FIRE PROTECTION ENGINEER - CODE CONSULTANT

July 26, 2005

Re: Recommendations resulting from the World Trade Center Investigation

APPROXIMATE DEBRIS LOCATION ON THE 91st FLOOR OF WTC 1

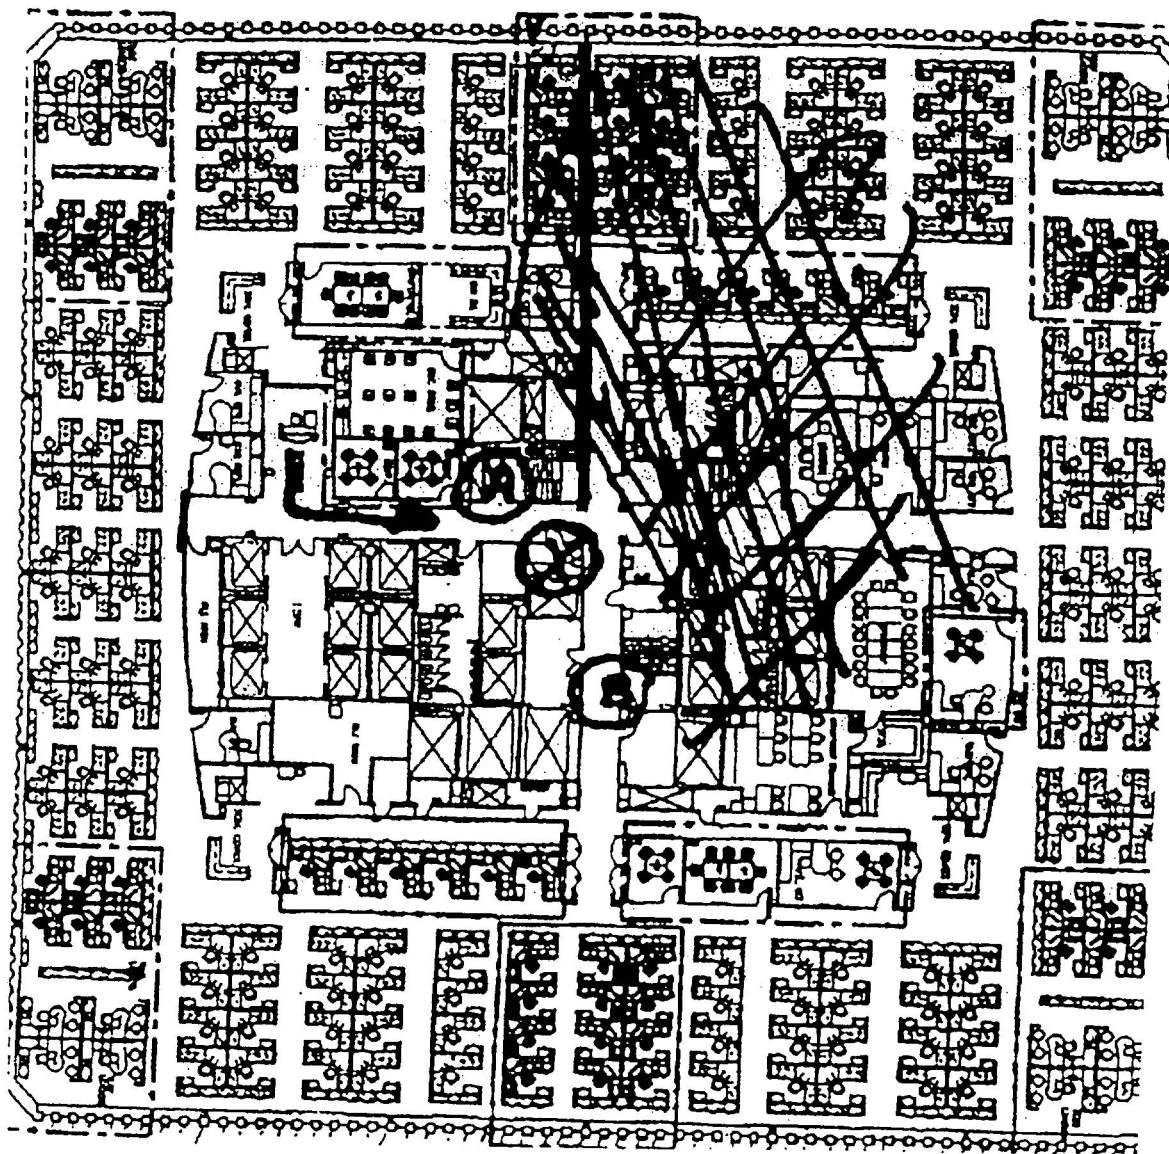
In Chapter 2, Section 2.2.1 concerning WTC 1 is a statement to the effect “Partial collapse of floors in this zone appears to have occurred over a horizontal length of approximately 65 feet. The 65 foot figure would be sufficient to effect all 3 stairways. Section 2.2.1.3 Evacuation, concerning WTC 1 and 2 contains the statement “People within and above the impact area could not evacuate, simply because the stairways in the impact area had been destroyed”. So, even though the buildings remained standing for more than an hour, persons above the 2-4 impact areas no longer had a stairway to use.

In August, 2002 I sent a letter to both the New York Fire Department and Building Department Commissioners. These letters outlined just how building codes had modified exit stairway requirements. A copy of that letter is enclosed. I believe that will adequately clarify my position. Had the 3 stairways been “widely separated”, at least one would have been available for the use of those above the fire involved floors.
